November 18, 2024

RE: Addendum to Hydrogeological Report for the Neches and Trinity Valleys GCD
Carrizo Sand Wellfield – Redtown Ranch Property, Anderson County, TX

Response Letters provided by AGS (Dated October 28, 2024)
and Mr. John Stover (Dated October 23, 2024)

Figure 1. Analytical modeled cumulative 50-year drawdown in the Carrizo Sand

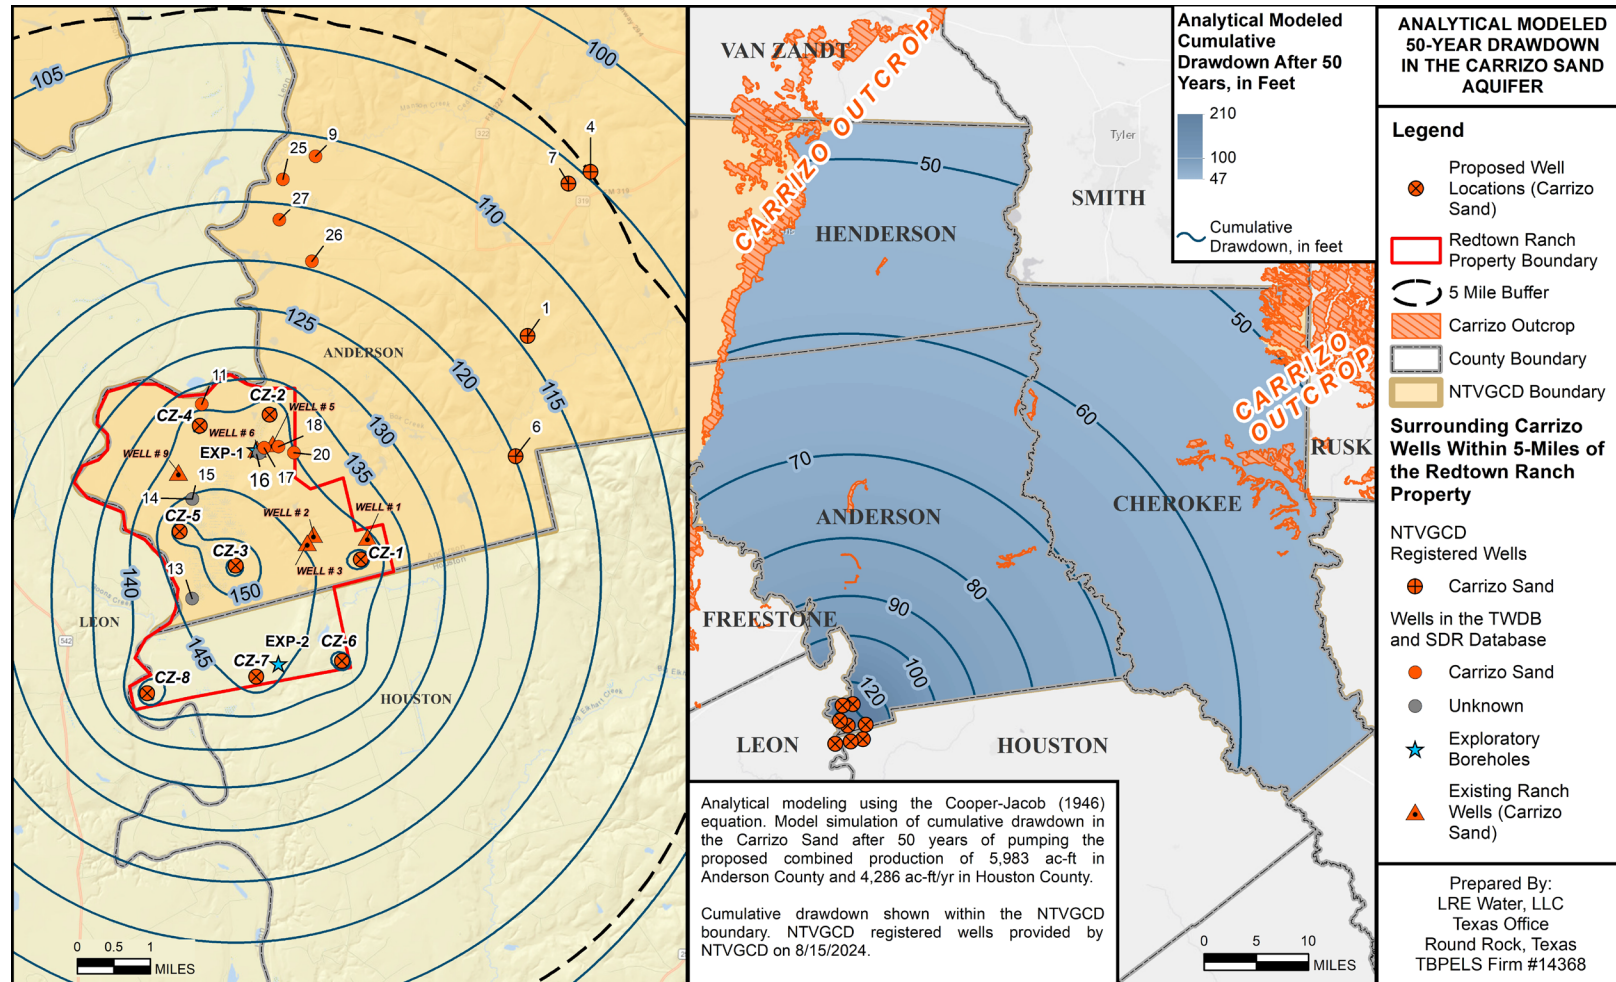
While the decisions about the completeness of the report will be up to our groundwater hydrologist, there are several things that I would like to see included, such as illustrations or maps showing the cone of depression depicting the contours for impacts for all of the wells listed in Appendix B in the LRE Water Report of September 5, 2024 for the well fields. The hydrologist has indicated that I will receive a response from him on this, this week.

I do not recall suggesting or agreeing to a report limited to a five year period. I have reviewed my notes and did not find anything in them that addresses the length of time that the report should cover. You must have misunderstood me. A five year period is not adequate for legal and scientific use.

Cumulative drawdown in each proposed well was calculated by superposition of drawdown effects and is equal to the sum of the individual drawdowns caused by each pumping well. The cumulative drawdown in the proposed wells after five years is presented in Table 3. A drawdown contour map after five years of pumping is provided in the Hydrogeologic Report (Appendix B). Cumulative drawdown in the proposed wells after 50 years of pumping is presented in Table 4. Illustrations showing the cone of depression depicting the contours for impacts for all wells listed in Appendix B of the LRE Report (Appendix B) after 50 years of pumping is presented in Figure 1 (as requested by Mr. John Stover – See Appendix A).

Figure 2. Numerical modeled marginal drawdown in the Carrizo Sand (Layer 6) from "Proposed CZ" after 5 years (2025-2030)

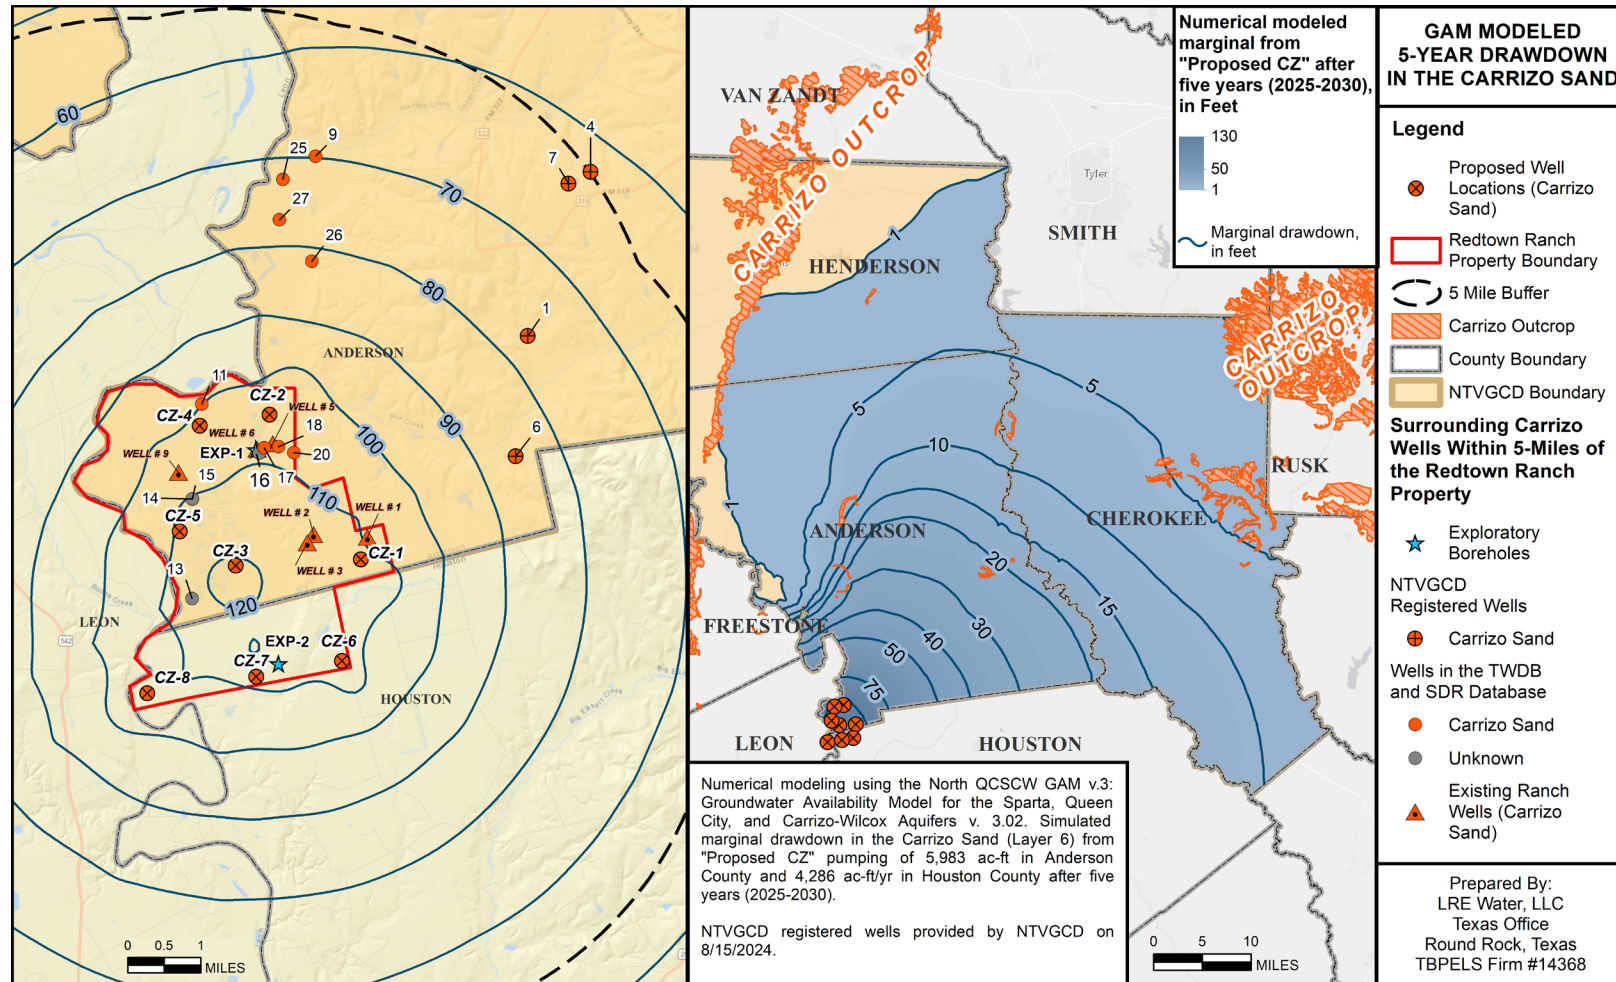
LRE compares the water level decline after 5 years from the project to the DFC drawdown noted in the tables as "Simulated "Base Run" Scenario 33 (TM 21-01)". The DFC drawdown noted in the comparisons is the simulated water level decline in 2080. We request that LRE provide a comparison with the simulated water level decline from the project in 2080.

- Drawdown from the “Proposed CZ” after five years from 2025 to 2030 (Figure 2)
- Drawdown from the “Proposed CZ” after 50 years from 2025 to 2075 (Figure 3)
- Residual drawdown (recovery) five years after “Proposed CZ” stopped from 2075-2080 (Figure 4).

Figure 3. Numerical modeled marginal drawdown in the Carrizo Sand (Layer 6) from "Proposed CZ" after 50 years (2025-2075)

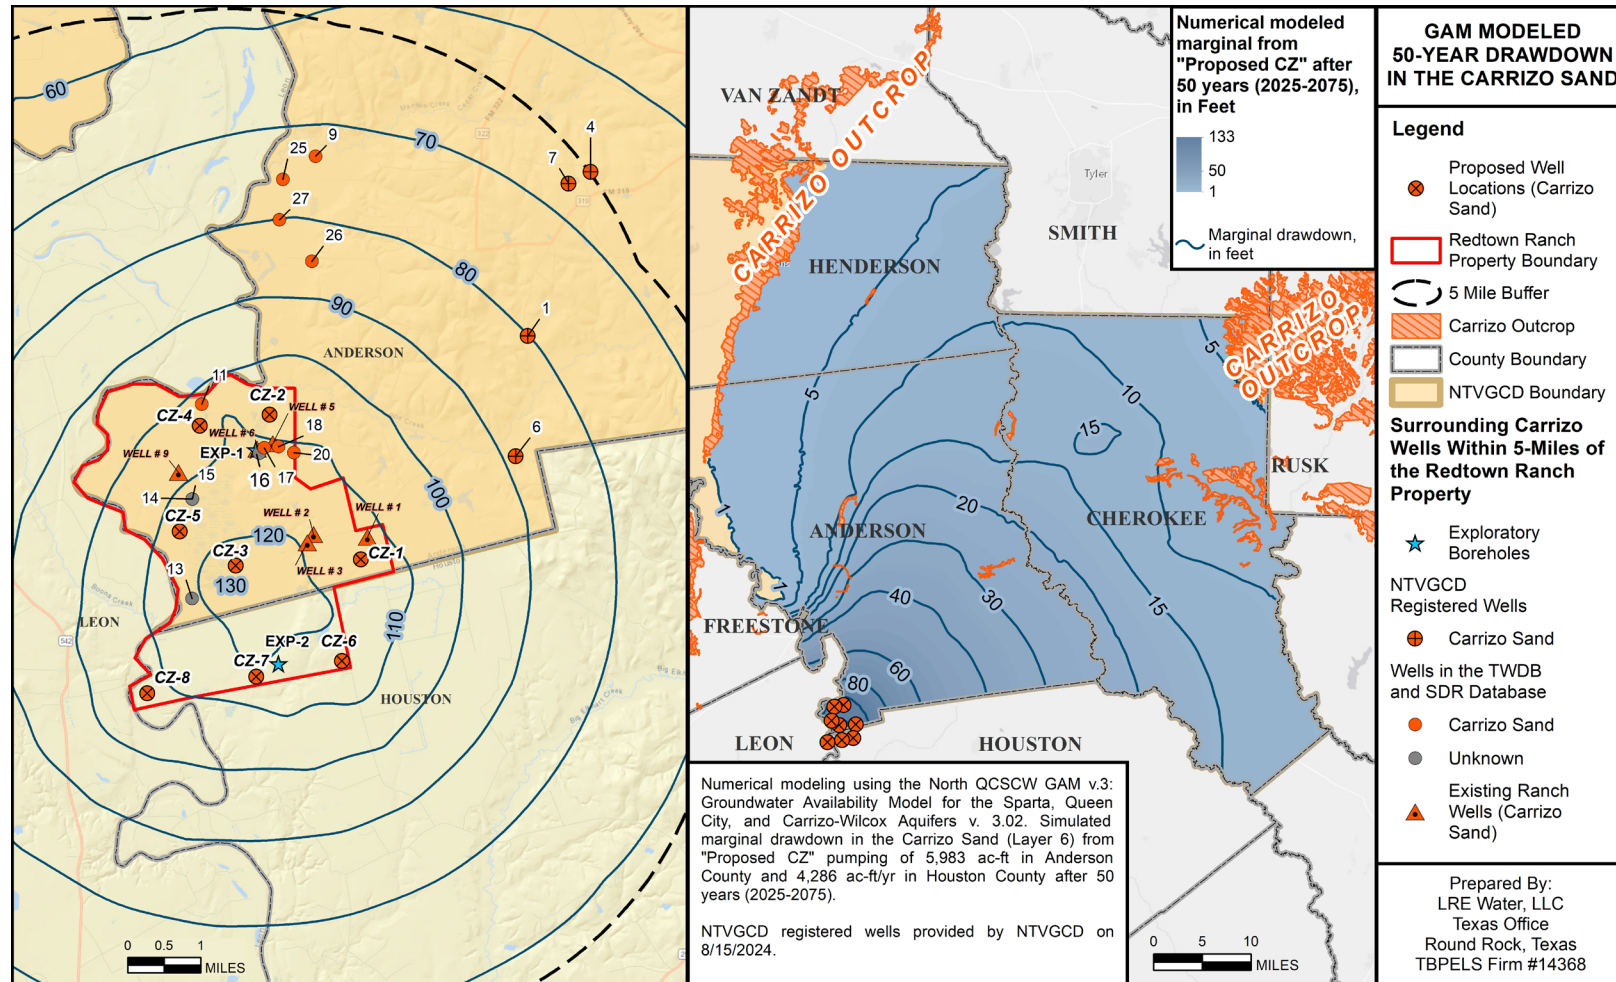
1. Yes, the 2025-2075 is fine for the 50-year run.
2. Yes, repeating the 2080 stress period is fine. Please show recovery results after 5 years (2080) also.
3. If the auto-flow reduction is required for convergence, that is fine. I obviously cannot speak to how the District will receive changes to the model or other approaches for estimating impacts, but I am open to considering your technical approaches to addressing model limitations.

Figure 4. Numerical modeled recovery (residual drawdown) in the Carrizo Sand (Layer 6) from "Proposed CZ" after 5 years (2075-2080)

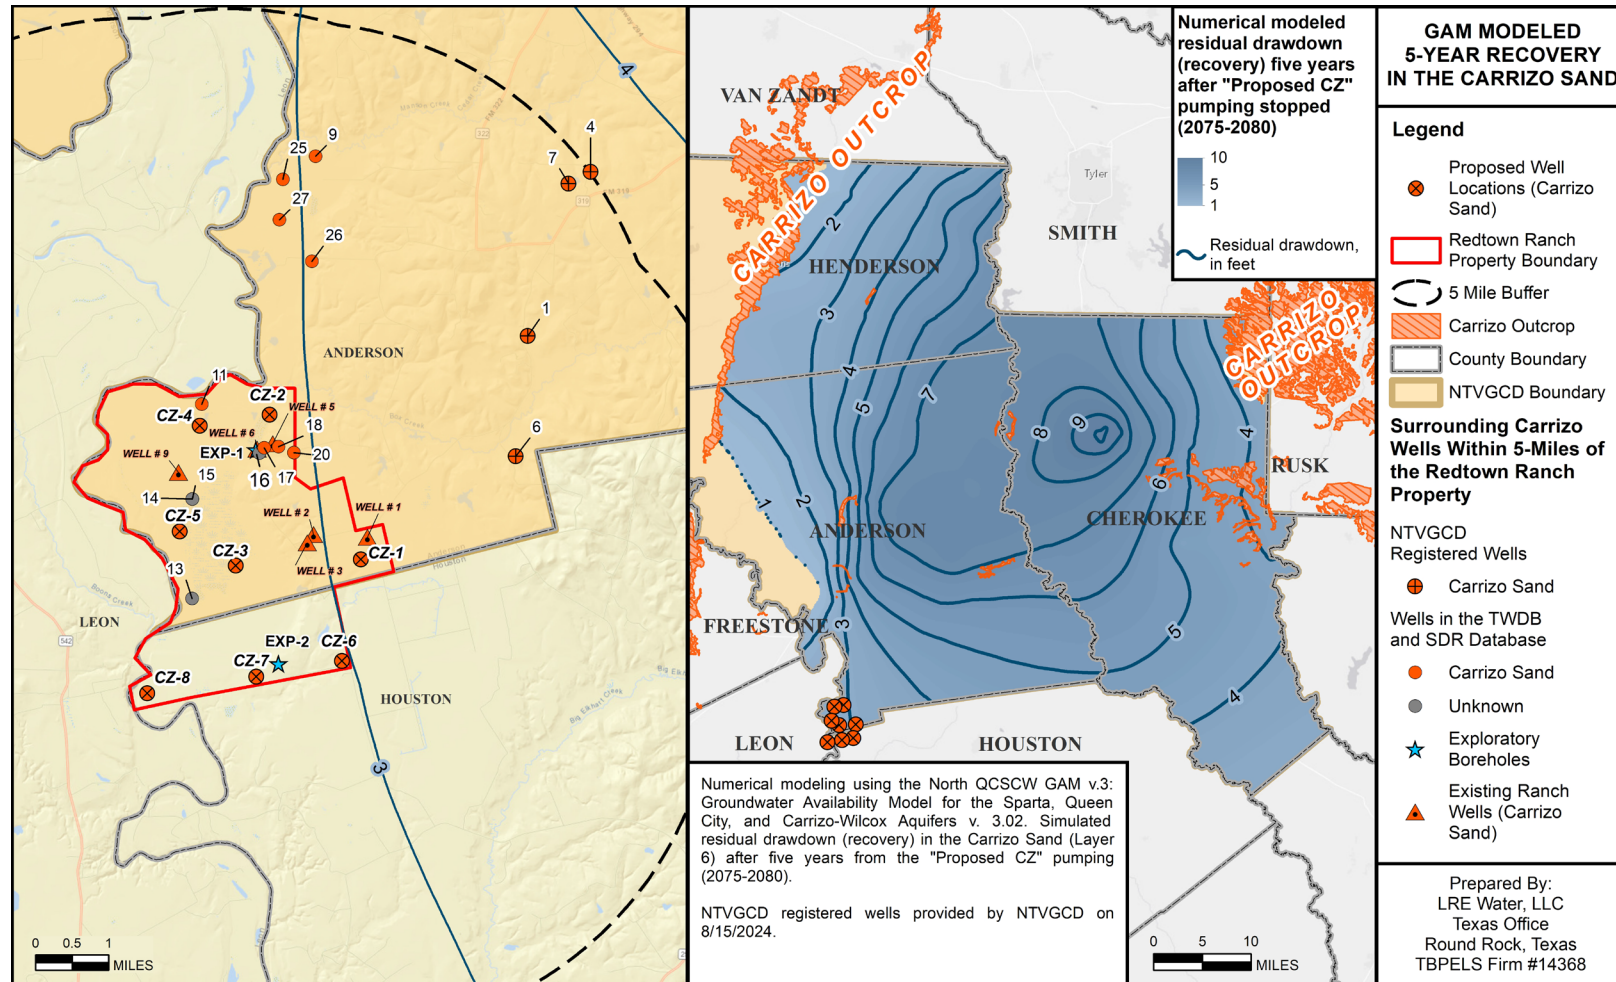
For the numerical modeling using the TWDB GAM, the recovery time was not documented in the hydrogeologic reports. We ask that LRE document the recovery time using the TWDB GAM.

Please model 5 years of recovery with the existing model out to 2080.
